# BUILDING 38 REMOVAL ACTION

### **ADDENDUM 1**

Public Review Draft

May 2003

Figure 1  
Location of PRS  
267, 273 & 303

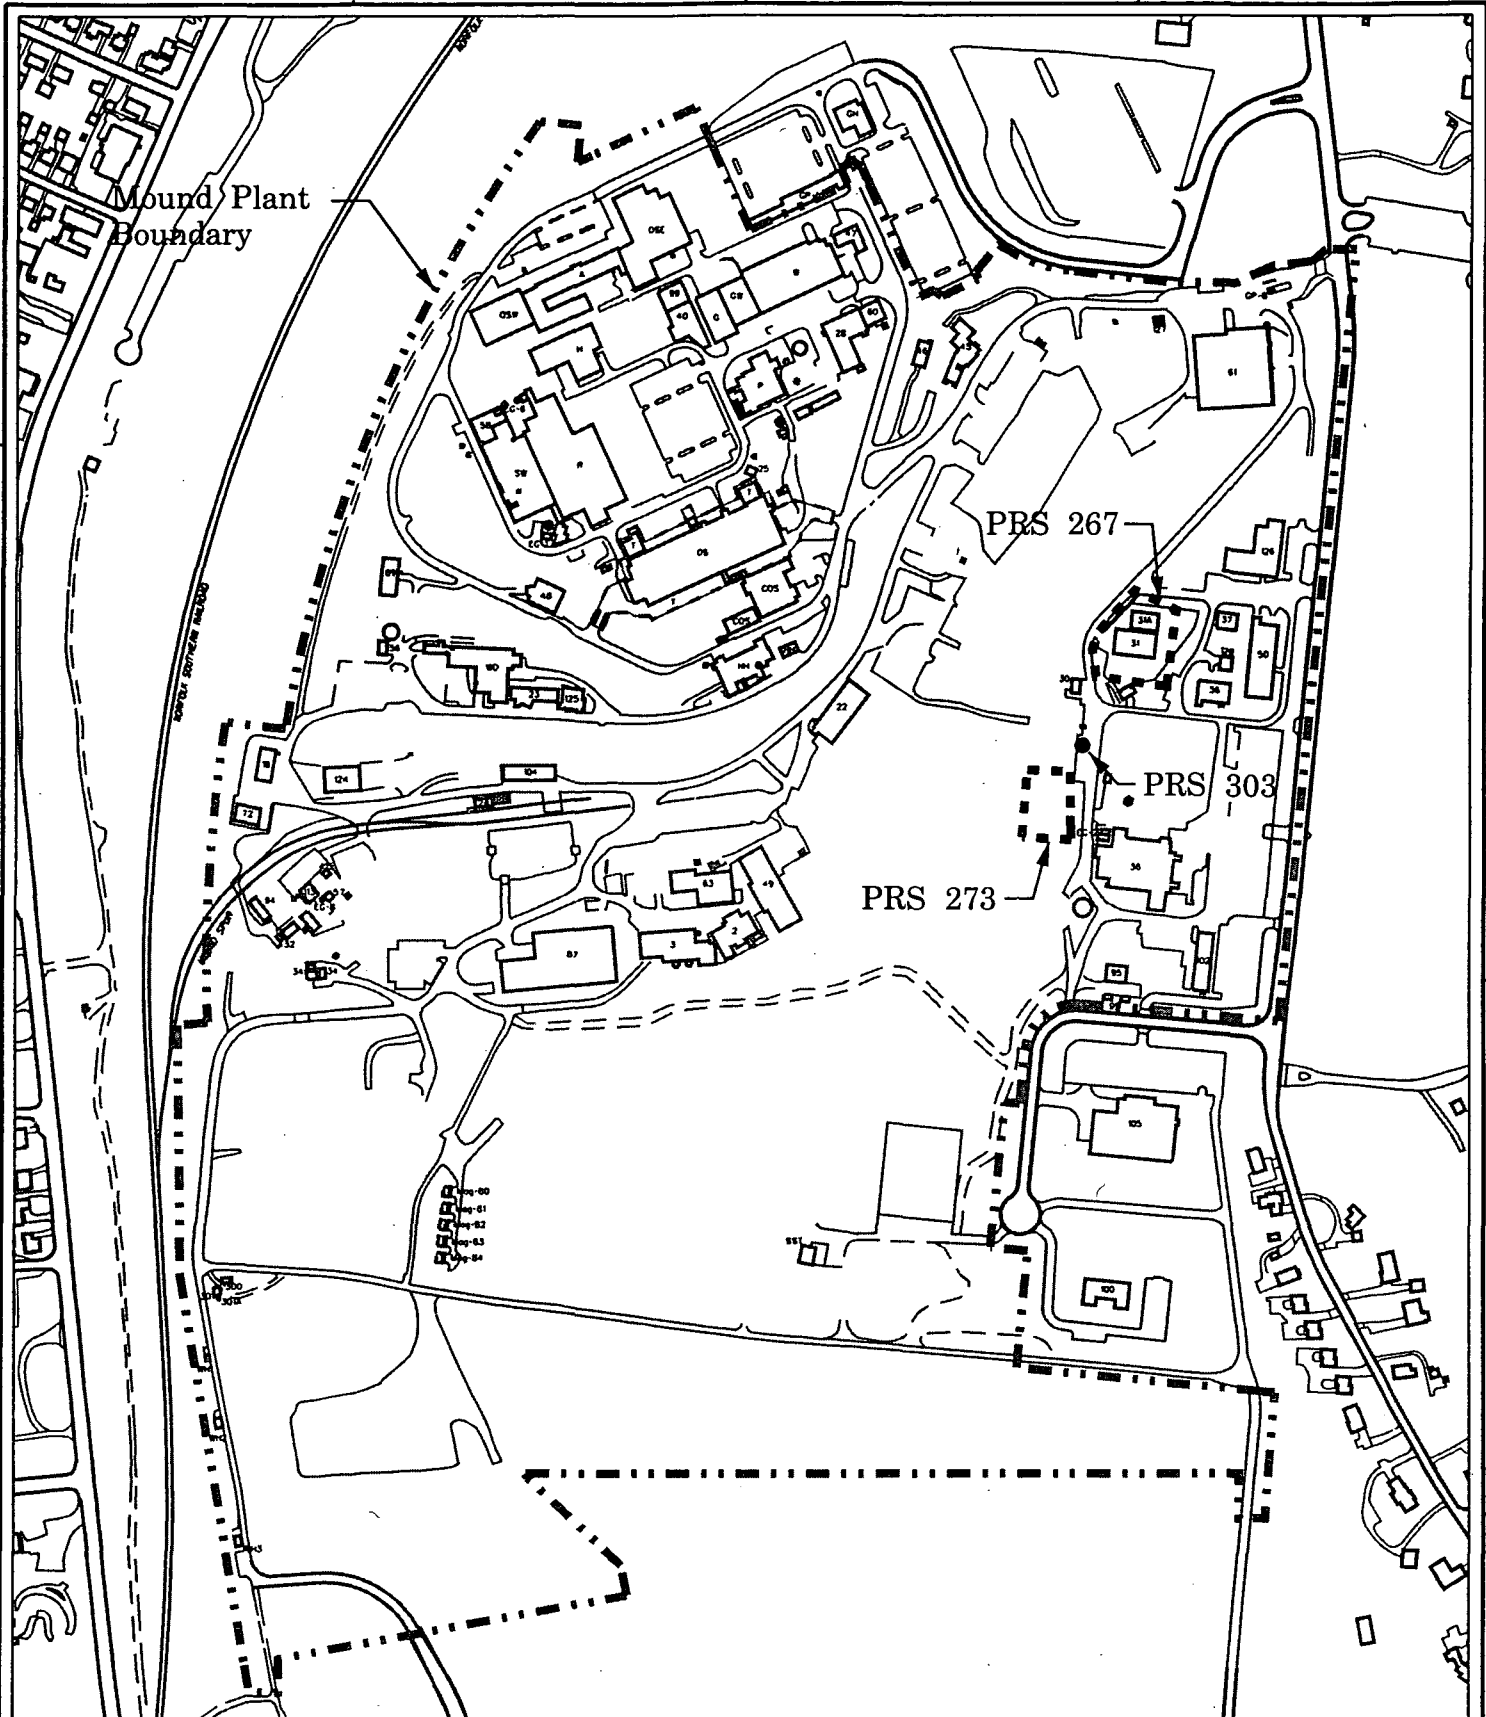
The Miamisburg Closure Project is a site on the southern border of the city of Miamisburg in Montgomery County, Ohio. The additional removal action is proposed for PRSs 267, 273, and 303 (Figure 1). ***All other PRSs listed in Tables 5.1 and 5.2 are accounted for in the Building 38 Action Memorandum.***
